PROJECT NAME: BARRE CITY
 PROJECT NUMBER: FECC F 026-(K34) C/2
 FILE NAME: z85b010bdr_if_c2
 PROJECT LEADER: G. BAKOS
 DESIGNED BY: D. PECK
 STREET LIGHTING PLAN #5

PLOT DATE: 3/9/2011
 DRAWN BY: D. PECK
 CHECKED BY:
 SHEET 83 OF 339

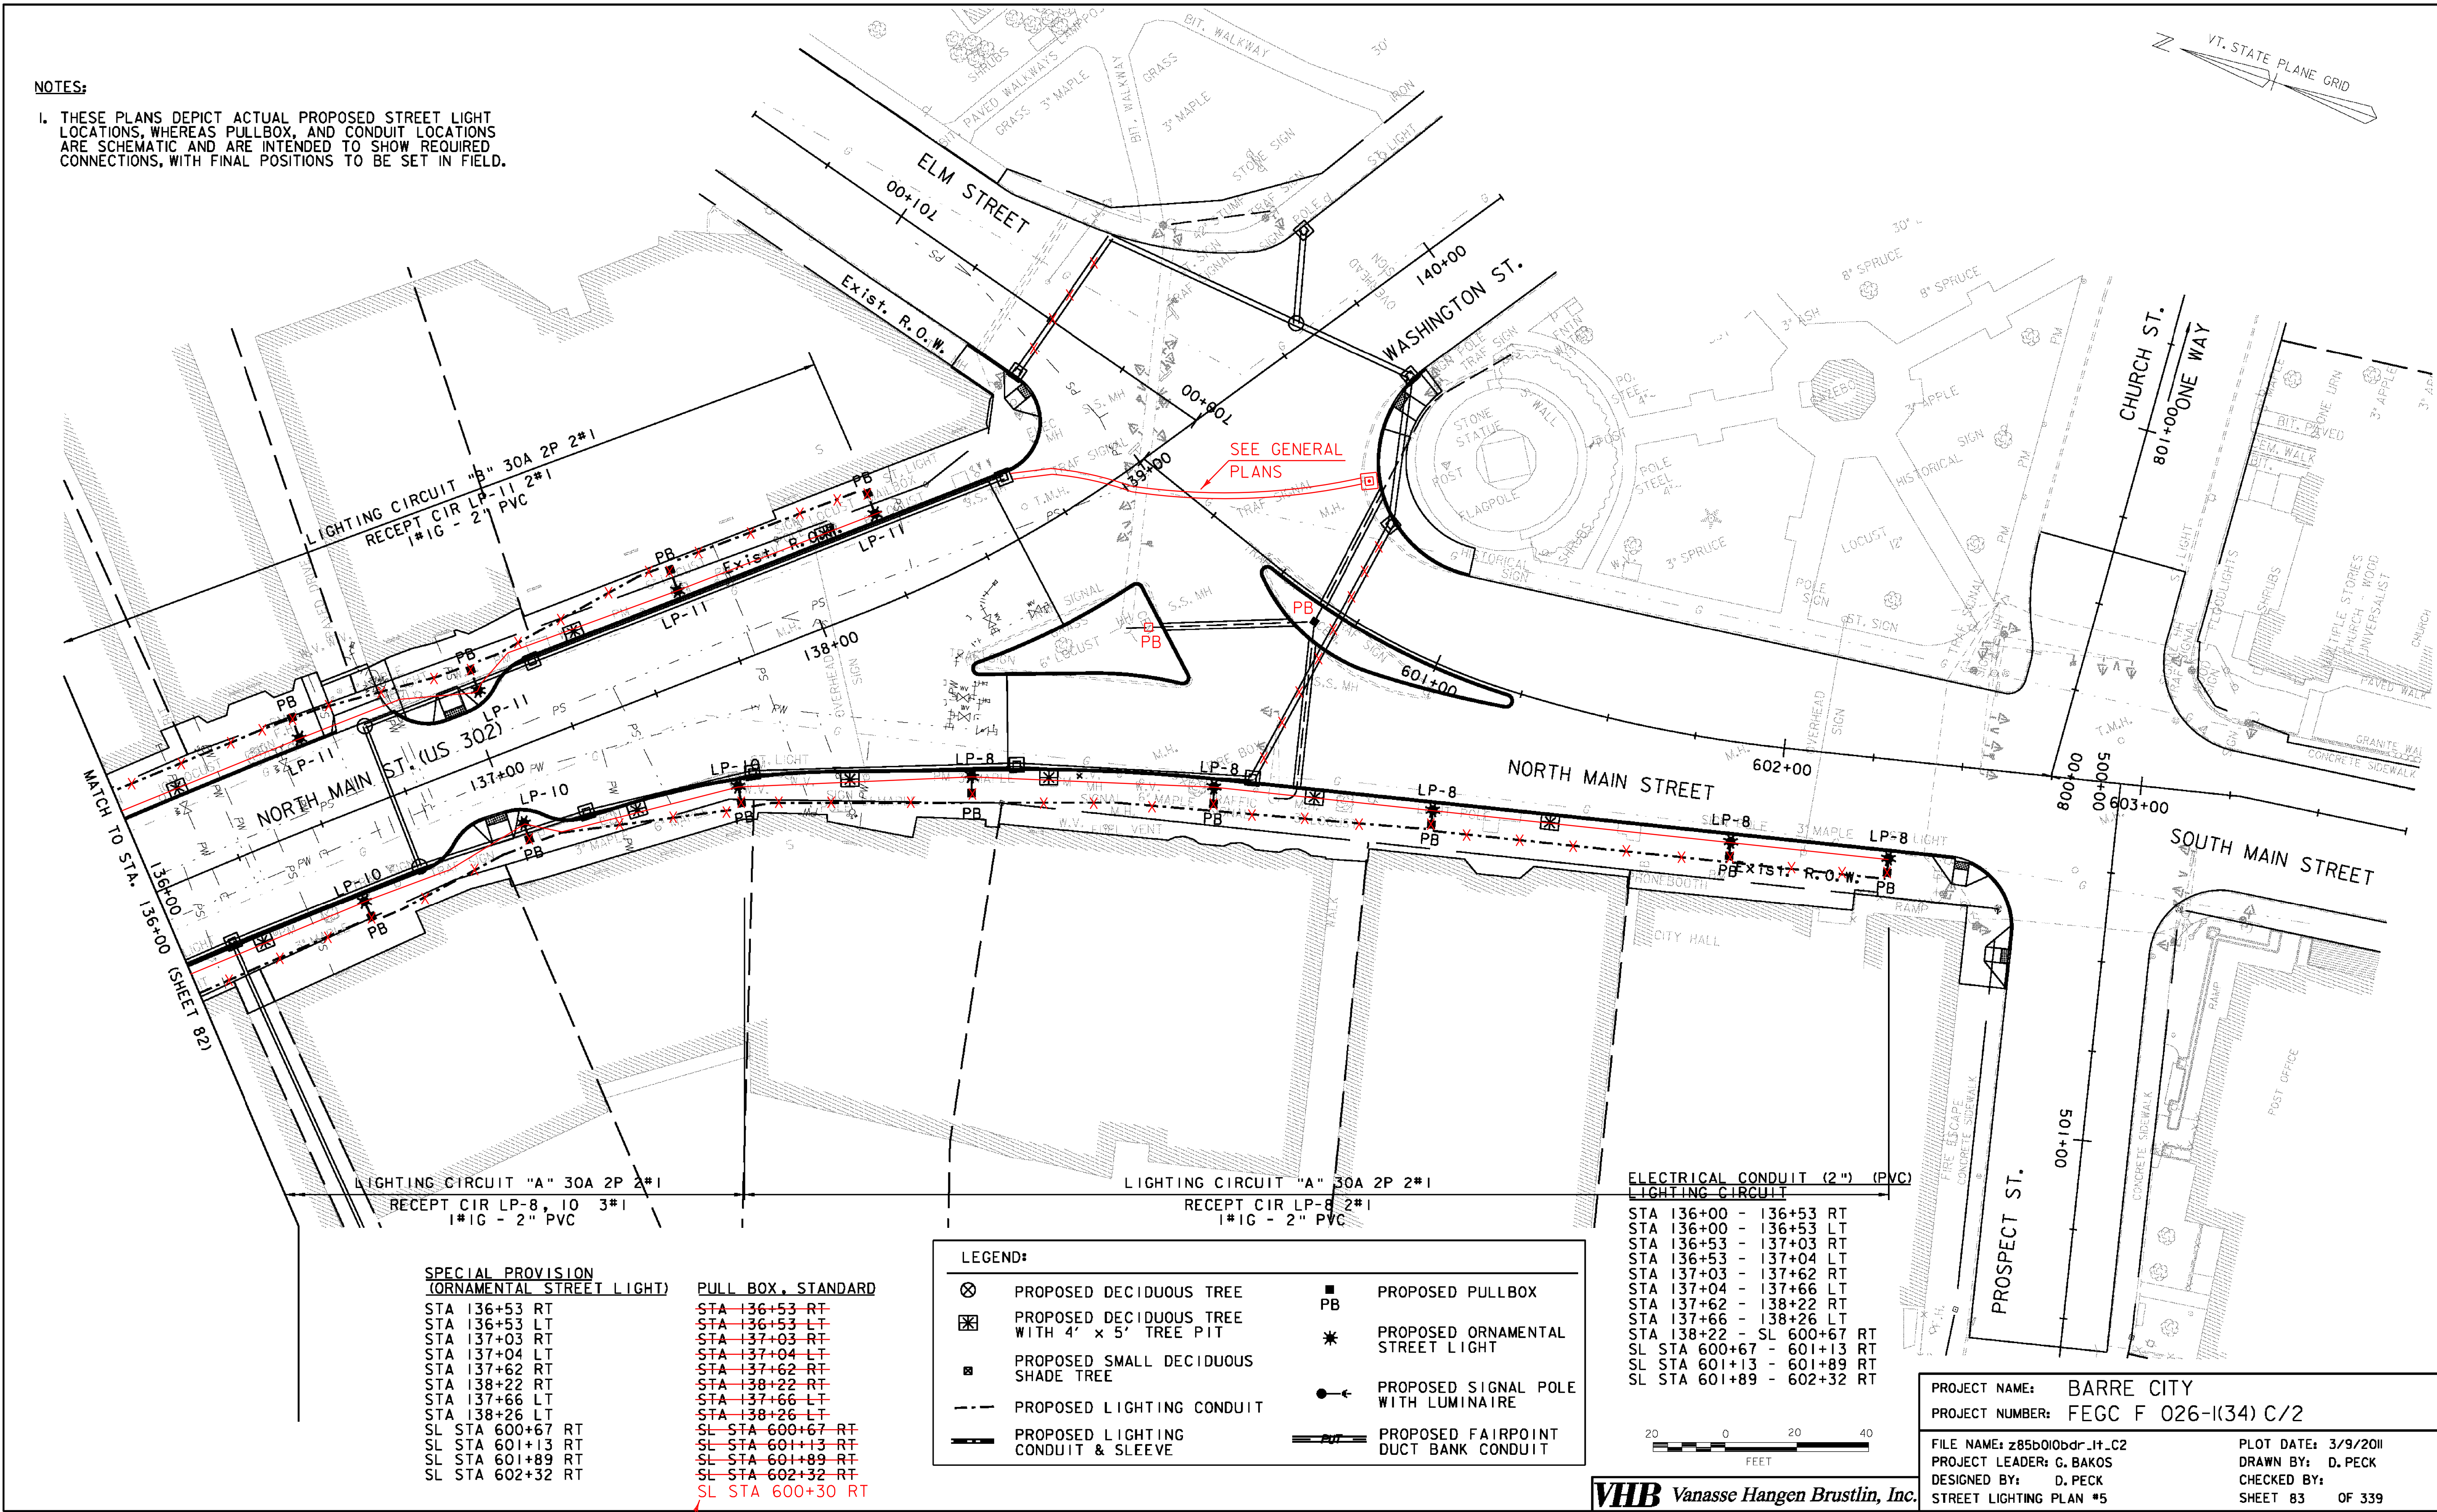
← THIS ONE WAS INSTALLED
